Green Lake County's Inspection Report

1. Type of Inspection (check all that apply) ☒ Annual ☐ Major Storm ☐ Site
2. Date of Inspection: 10/29/2025
3. Drainage District Name or Number: Seneca-Warren
4. Location of Damage or Complaint:
Looked at Junction of Town Drain and Lateral A, concern from Mike Eagan that his water cannot get into the Town Drain to provide drainage.
5. Name of person(s) making complaint or accompanying the inspection:
Mike Eagen, not present for inspection

Ditch/Trees – along corridor (Guden property)

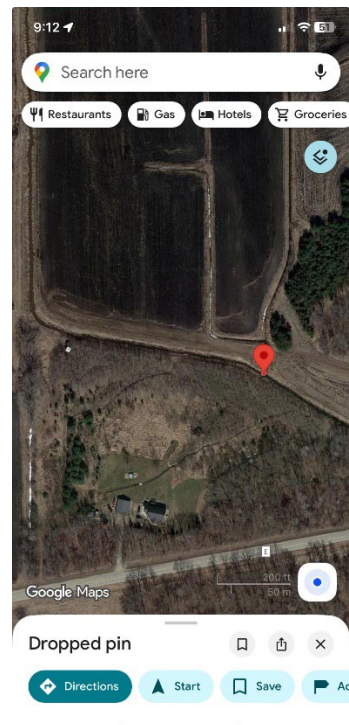
Thomas Guden, Question on time of year for inspection, impact on deer hunting, Thomas Suggested Spring is better. Then he wanted me to look at trees in corridor.

Overall, I think the ditch is working and depth is to specification.
Brush and tree removal in corridor should continue with a section or percentage done every year. Annual spraying of woody vegetation till grass crowds out.

Area of Concern – 284+54

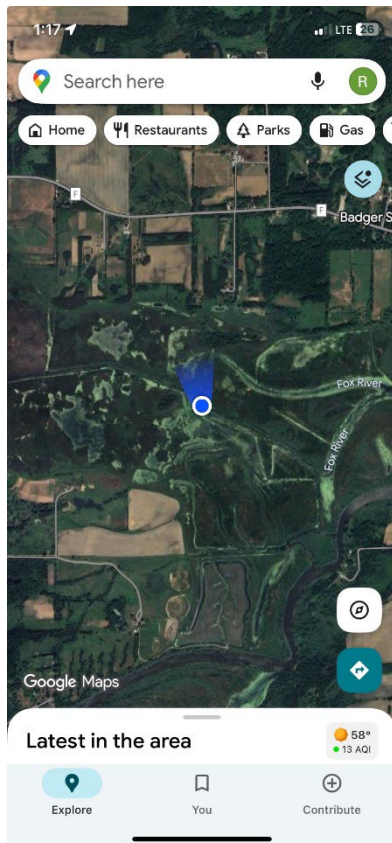
7. Repairs Proposed or Action to be Taken by Board (attach additional sheets if needed): No action needed at the junction of Town Drain and Lateral A at this time. Bottom is at design elevations. Zietlow did inspect portions of ditch on own and took photos, one concern area is on Schrock property, approximately at station 284+54.
